PZ15-00013 (DEV) Super 8 Façade Remodel

Current Planning Comments

**PZ15-00013 (DEV)
Super 8 Parking Lot and Improvements (Conceptual Review)
10/29/15**

Engineering Comments

**PROPOSED
MATERIALS & COLORS**

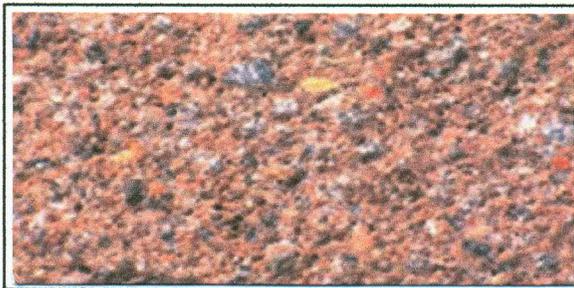
7. Proposed Color and Materials Board:
- a) The color proposed for the exterior wall does not comply with the City's Color Requirements. In addition, due to the height and the non-conformity of the existing building, it has been determined that the color cannot have an LRV (Light Reflectance Value) of more than 21% based upon the table found in Section 904, Color, SLDC.. Please provide a new color sample for review. In addition, please provide a color sample of the existing building for comparison purposes.

SITE PLAN

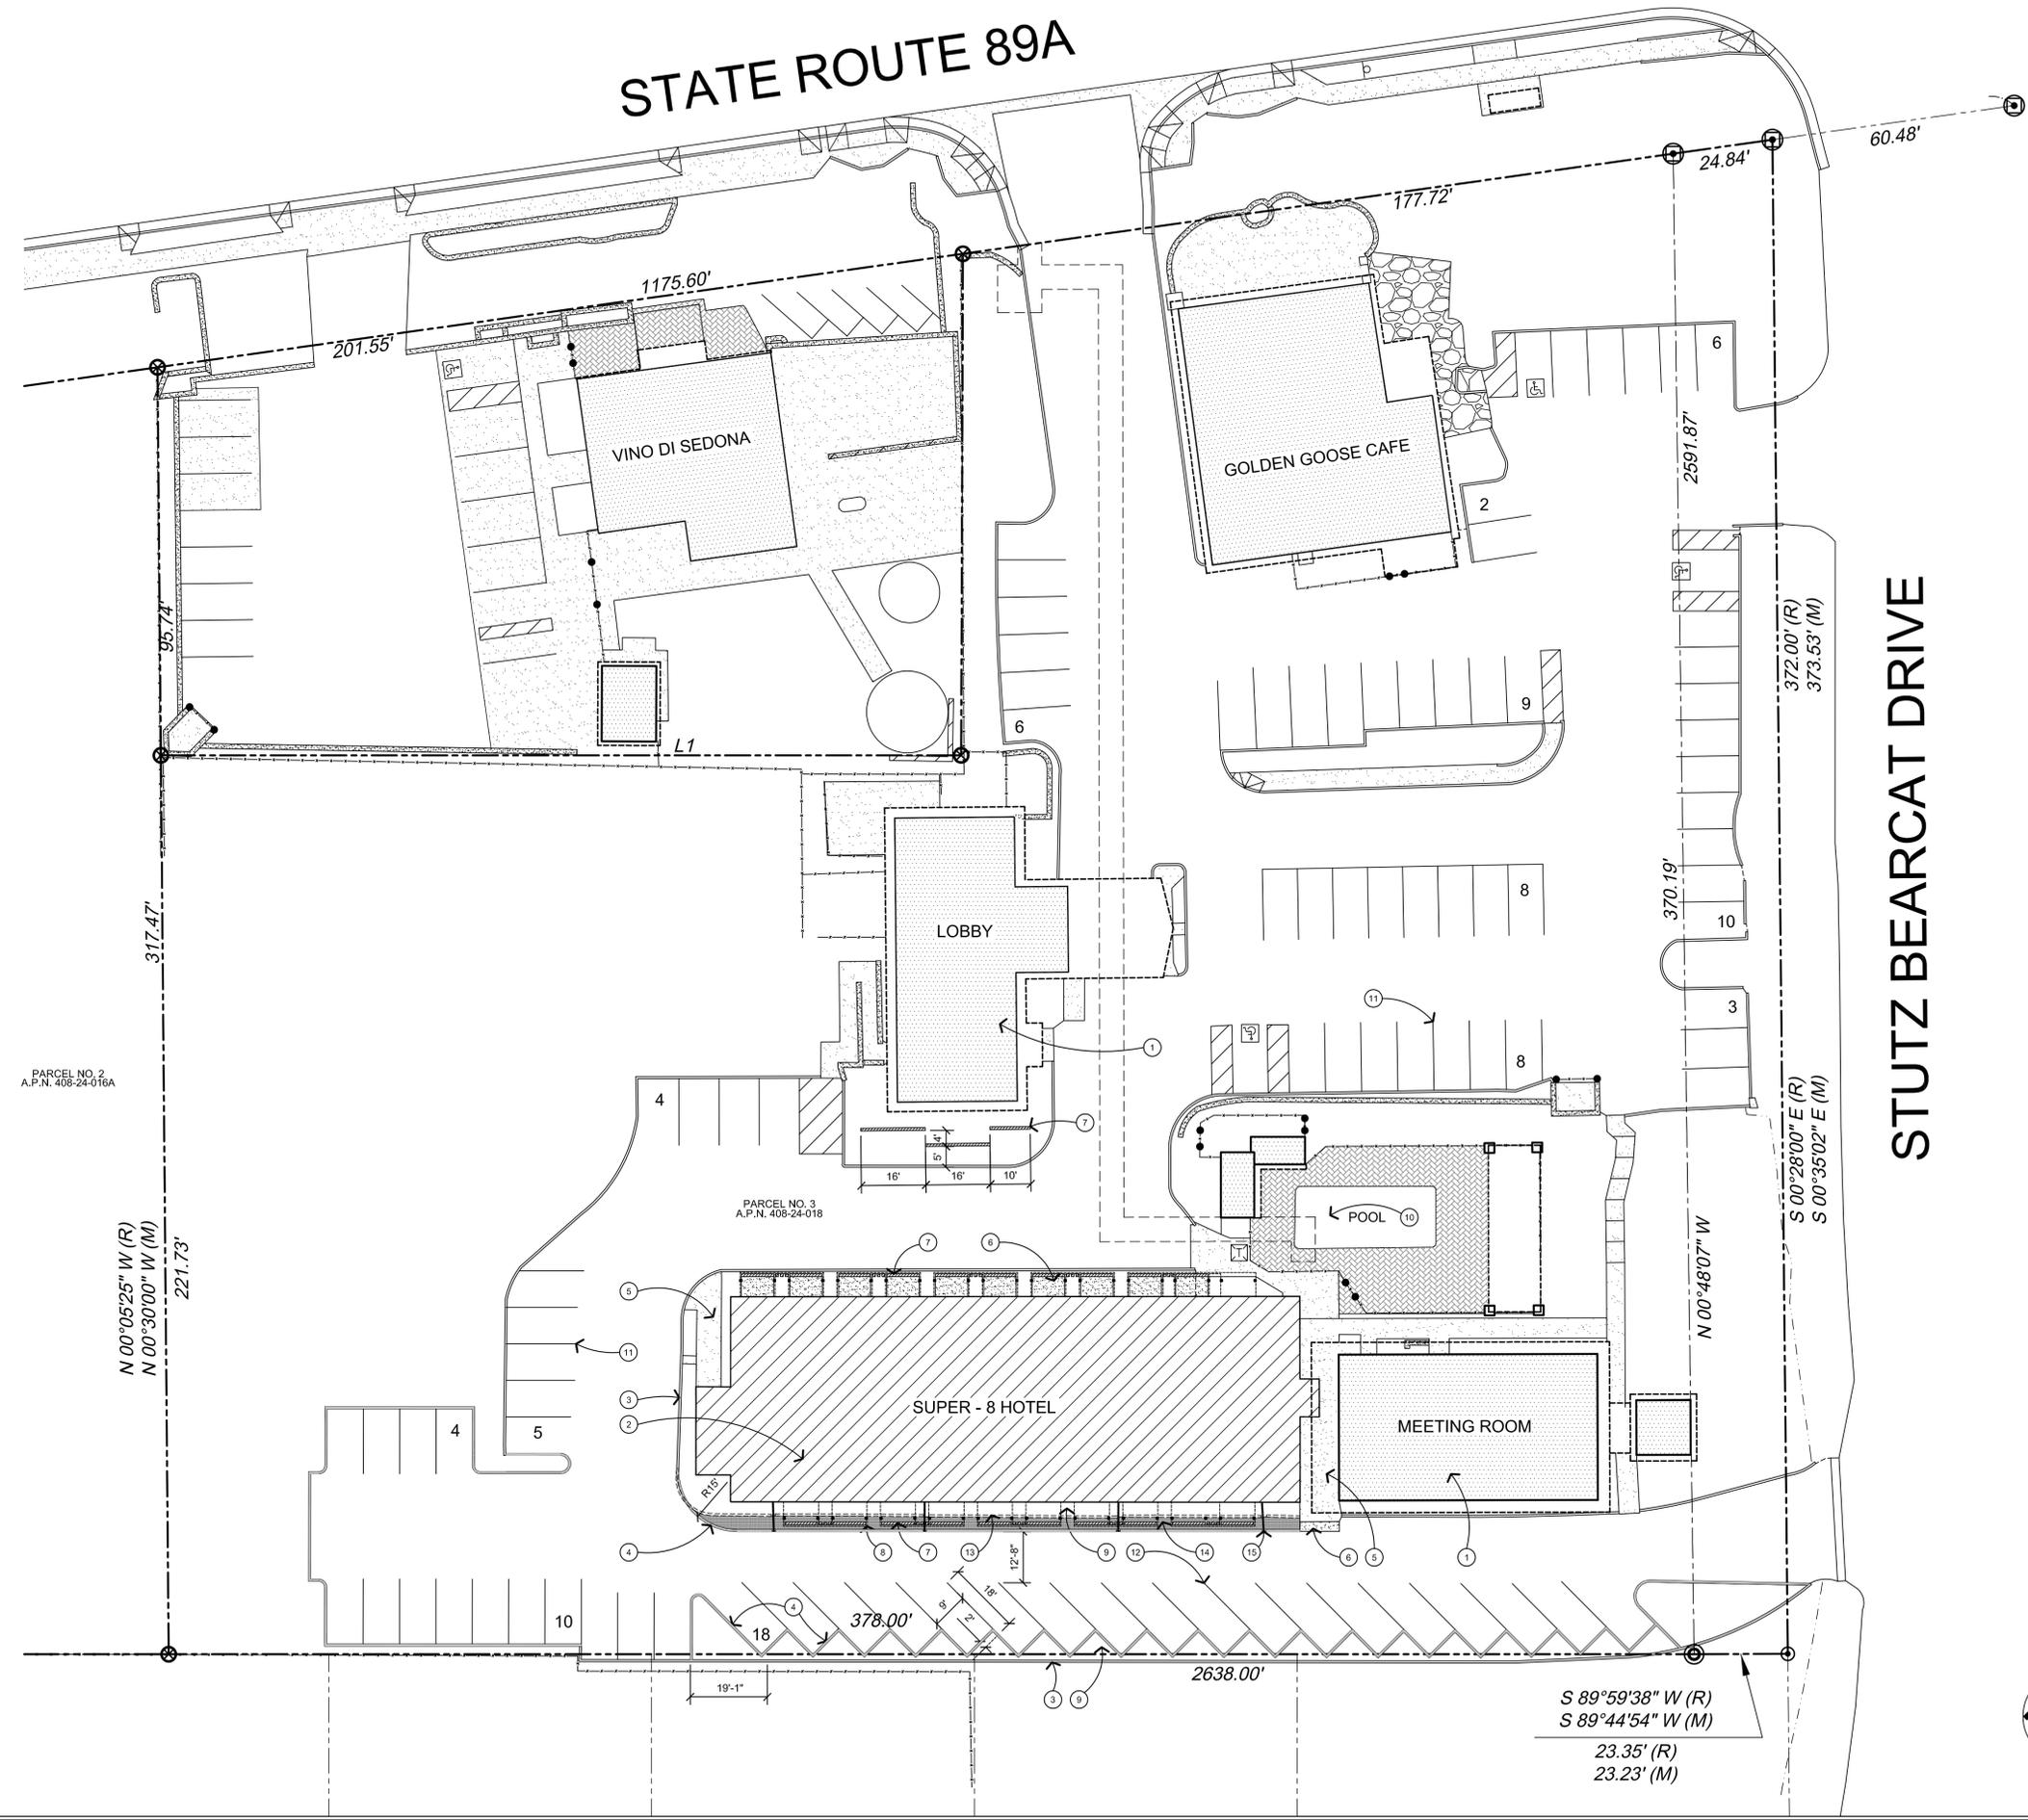
5. Site Plan:
- a) The site plan shows that the curb and reconfigured parking areas at the south end of the site encroach onto the neighboring property. All improvements must be located completely within the subject property. Please adjust plans accordingly.

- b) SLDC 907.02.C requires a screening of 6 feet in height between commercial parking areas and residential properties. This does not currently exist and needs to be provided as a part of this application. Please indicate the location and method of screening on the plans.

- i) A one way parking aisle with 45 degree angled parking requires a minimum aisle width of 13 feet. (See SLDC Figure 9-46) The site plan shows the parking aisle on the southern side of the building at 12'8", 4" short of the required width. In addition, based on the current layout, approximately 2 feet of the parking area encroaches onto the neighboring properties.

1. Backup turnaround at the proposed new parking area to the west must be a minimum of 12' in depth.
2. Keynote #4 calls for 6" curb height, per Land Development Code (912.05.J2), the maximum curb height that will be used as an overhang is 4".

3. Southern parking spaces encroach past the property line. In addition, the as planned aisle width between the curb and parking spaces is 12' - 8"; the minimum width required is 13'. It is recommended to decrease the angle to 30 degrees to ensure that the property line is not encroached, and to provide adequate spacing between the parking spaces and the new concrete curb. The minimum required aisle width for 30 degree angle parking spaces is 12'.

4. Please refer to the City Land Development Code Section 912.08 to view other options.
5. In the new southwestern parking area, the two sets of parking spaces show a 25' length between them, the minimum is 26'.

6. Straight parking spaces are currently designed as 16' long; the minimum length required is 18' long. 16' is fine as long as it includes a 2' overhang.

EXTERIOR ELEVATIONS
SCALE: 1/8" = 1'-0"

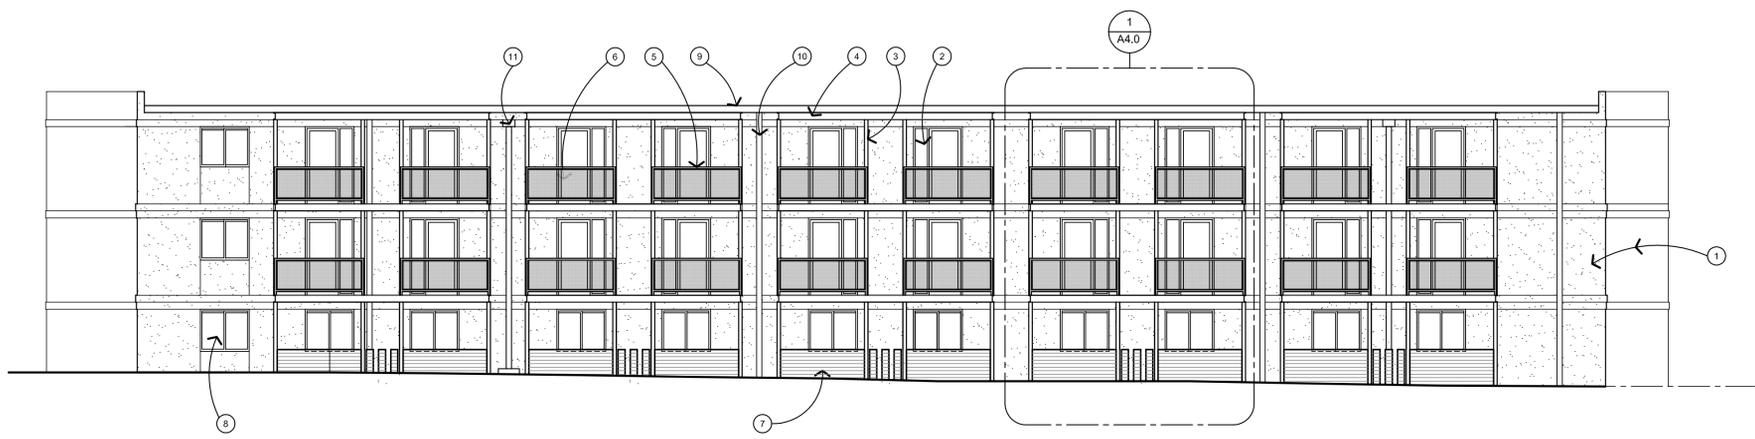
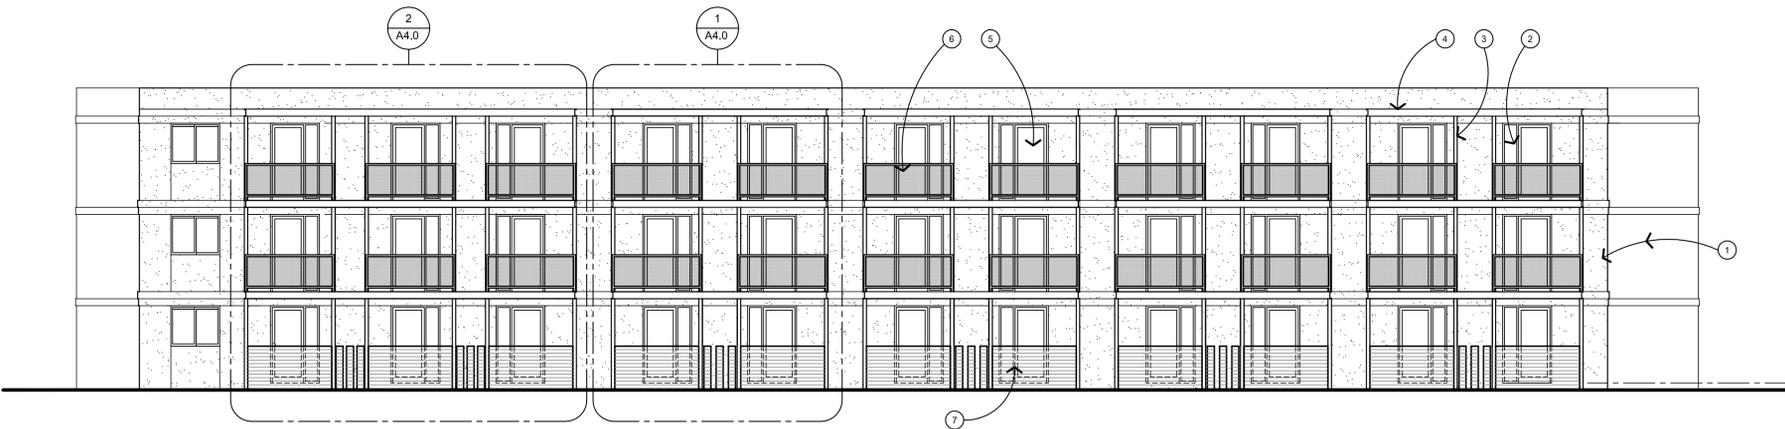
- c) Please note that changes made based on other comments may require the site plan to be changed as well.
6. Exterior Elevations:
- a) Please explore options to create a more varied façade. While the proposed patios and decks add more dimension to the flat wall, they are repetitive. Please determine if there is a way to alter the width and/or depth of some of the patios to create greater visual interest and articulation.

- b) Please provide elevations of the west and east ends of the building. Provide a calculation for the unrelieved building plane (SLDC 903.03.C) and exposed mass heights (SLDC 903.03.D). If the building does not meet these requirements, consider adding additional landscaping and/or architectural features, as well as incorporating a change in materials to break up the mass of the wall.
